# UNITED STATES PATENT AND TRADEMARK OFFICE

APPLICATION NO.	FILING DATE	FIRST NAMED INVENTOR	ATTORNEY DOCKET NO.	CONFIRMATION NO.
10/720,173	11/25/2003	Eun-Bong Han	102-1003	4330
38209	7590	05/08/2007		
STANZIONE & KIM, LLP 919 18TH STREET, N.W. SUITE 440 WASHINGTON, DC 20006			EXAMINER LIANG, LEONARD S	
			ART UNIT 2853	PAPER NUMBER
			MAIL DATE 05/08/2007	DELIVERY MODE PAPER

**Office Action Summary**

## DETAILED ACTION

FIG. 1  
(PRIOR ART)

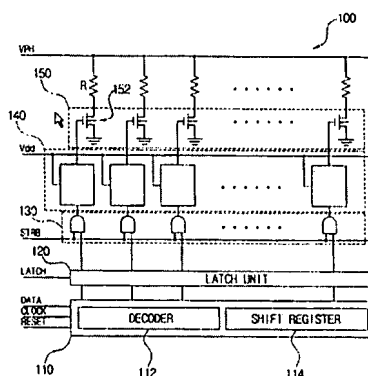
- {claim 1} An inkjet printer head driving apparatus having a plurality of heating elements and nozzles (figure 1, reference 100); a switching unit turning on and off each of the heating elements to heat ink corresponding to selected nozzles to eject the ink (figure 1, reference 150); a level shift unit having a level converter converting a potential level of a signal inputted therein into a predetermined potential level to drive the switching unit (figure 1, reference 140), a buffer to output the converted level of the signal (figure 2, reference 144), and a transient time extending part provided with at least one time extending element to extend by a predetermined time a transient time of the output potential level of the signal during which the potential level of the signal inputted from the level converter to the switching unit is converted from a first signal level to a second signal level and vice versa (figure 1-2, reference 140); a control unit receiving an external

data signal, decoding the received data signal, and outputting the decoded data signal as a nozzle selection signal to the level shift unit to select the selected nozzles corresponding to a to-be-recorded image from the nozzles (figure 1, reference 110)

- {claim 4} wherein the transient time extending part comprises a first inverter inverting the signal outputted from the level converter (figure 2, reference INV1); and a second inverter extending the transient time from the first signal level to the second signal level or a second transient time from the second signal level to the first signal level in correspondence to an output signal of the first inverter (figure 2, reference INV2)

- {claim 8} An inkjet printer head driving apparatus having a plurality of heating elements and nozzles (figure 1, reference 100); a control unit generating a control nozzle selection signal to select a heating element and a nozzle corresponding to an image to be printed (figure 1, reference 110); a level shift unit generating a first nozzle selection signal having a first transient time, during which a level of the first nozzle selection signal is changed between first and second levels, in response to the control nozzle selection signal, and generating a second nozzle selection signal having a second transient time extended by a period from the first transient time of the first nozzle selection signal (figure 1-2, reference 140); and a switching unit turning on and off the heating element according to the second nozzle selection signal (figure 1, reference 150)

- {claim 31} An inkjet head driving unit (figure 1); a control unit to generate a nozzle selection signal to select a nozzle having a heating element (figure 1, reference 110); a level shift unit to convert the nozzle selection signal to have a predetermined level to drive the heating element between a logic high and a logic low and having a buffer to output the converted nozzle selection signal (figure 2, reference 144), and one or more logic units to increase a time required to change the output nozzle selection signal between the logic high and the logic low (figure 1-2, reference 140); and a switching unit to turn the heating element on and off according to the output of the level shift unit (figure 1, reference 150)

The examiner respectfully disagrees. The examiner has repeatedly demonstrated that the AAPA discloses the transient time extending part in the fact that the right part of buffer 144 discloses a first PMOS and first NMOS which necessarily extends the transient time, even though the extent of this function may be minimal or even negligent when compared to the time extending characteristics of transient time extending part 243. The applicant still has not rebutted these arguments with respect to figure 6.
